90 Burnett North Fork Bridge Cost Increase

Motorized Recreation Grant Application

PLAN OF PROPOSED IMPROVEMENT
FOR
Trail 45 Bridge Over North Fork Flowage Replacement
IN THE
Town of West Marshland
Burnett County, Wisconsin

NO.	DATE	REVISION	BY
STRUCTURE TR45 @ N. FK. FLWG			
DRAWN BY		PLANS	BY
		ZM	CK'D
BRIDGE ELEVATION EXHIBIT			SHEETEX1

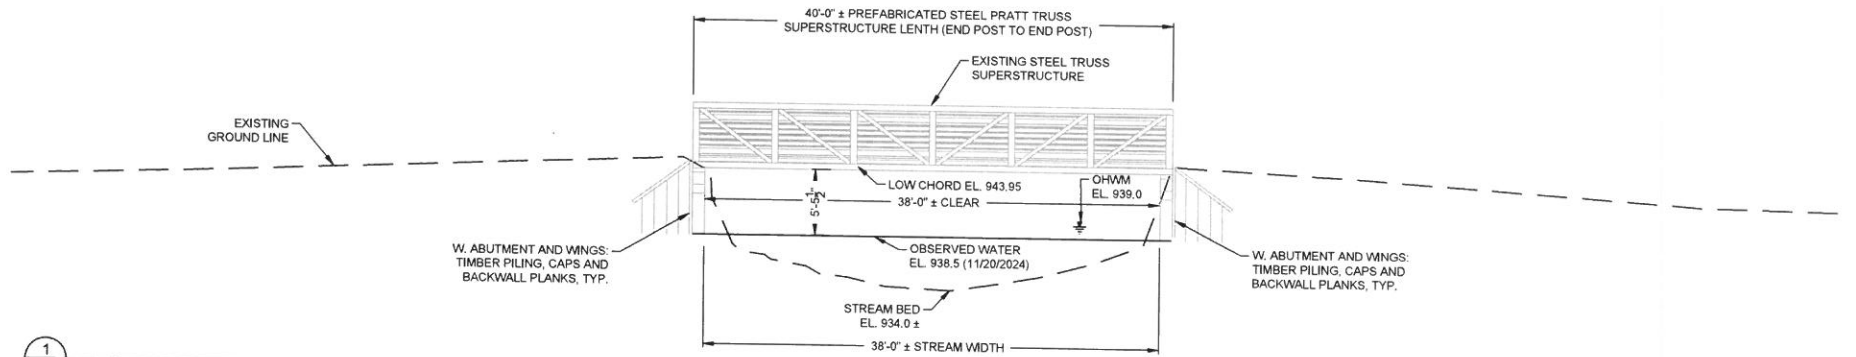
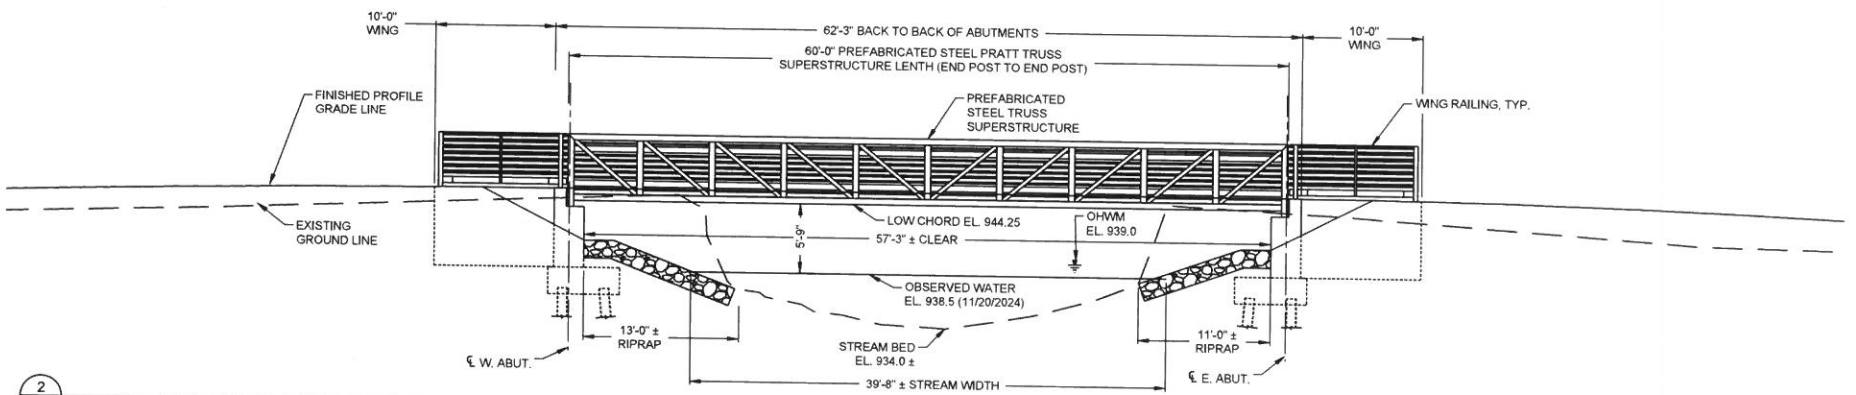
On behalf of Burnett County Forestry and Parks, please see the attached blueprint comparison document prepared by SEH Inc. As you recall, we visited the site on Nov. 12, 2024 to go over conceptual design issues for replacing the bridge over the pumphouse ditch that discharges into North Fork Flowage at Crex.

The multiple plan sheets provided to Burnett Co. were very detailed. I requested SEH to provide a simple addendum that would show the existing structure profile compared to the proposed bridge structure. Obviously the main purpose of my request was to provide you with a side-by-side comparison that would make a relatively easy regulatory decision on whether the proposed bridge would meet the "In-Kind Replacement/Maintenance of a Previously Permitted Structure" exemption. The proposed NR 320 WI Admin. Code includes codification of the "In-Kind" exemption and allows for modification (ie; doesn't need to be exact replication). The current bridge was permitted by Ed Slaminski under a short form application.

We are seeking a determination that the proposed bridge replacement would be exempt from additional Ch. 30 permitting process under the In-Kind Replacement exemption.

Good Morning Everyone; I agree with David's statement that "the proposed bridge would meet the "In-Kind Replacement/Maintenance of a Previously Permitted Structure" exemption. Be sure to send me photos of the completed project.
